# BMI260 Family - Product Change Notification

## Additional ASIC Fab Release

### **BMI260 Family PCN – Additional ASIC Fab release**

Document revision	1.1
Document release date	Apr 17 <sup>th</sup> 2020
PCN Tracking number	BST-BMI260-PN000-01
Technical reference code(s)	0.273.017.000, 0.273.017.001, ... -.002, -.003, -.004, -.008
Notes	Data in this document are subject to change without notice. Product photos and pictures are for illustration purposes only and may differ from the real product's appearance.

## 1.2 Product Labelling in Mass Production (Laser Marking)

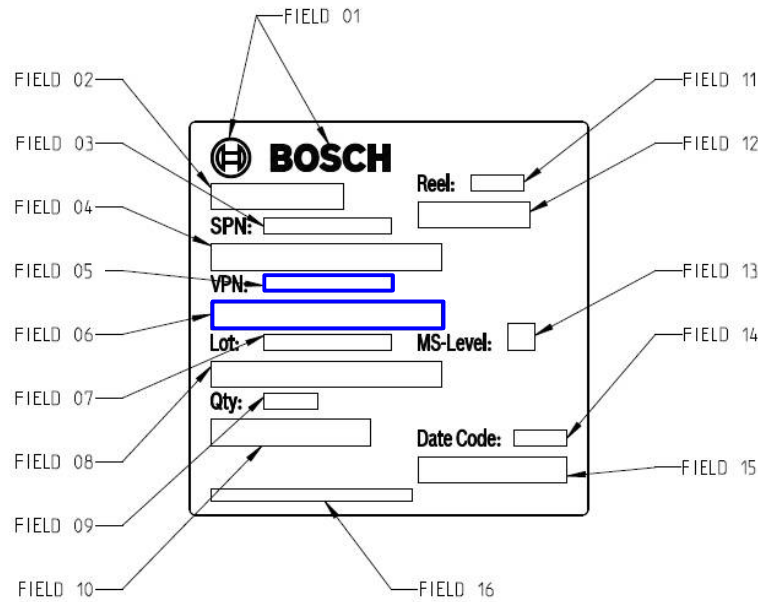
### Mass Production Laser Marking after PCN

Labeling	Name	Symbol	Remark
	Internal Code	L	1 alphanumeric digit, fixed, L ≠ "E" L = "P" or "L" or "W" or "N", internal use
	Product Identifier	V	1 alphanumeric digit, fixed, V = "5" to identify BMI260 product family
	Counter ID	CCC	3 alphanumeric digits, variable to generate trace-code.
	Pin 1 identifier top side	●	--
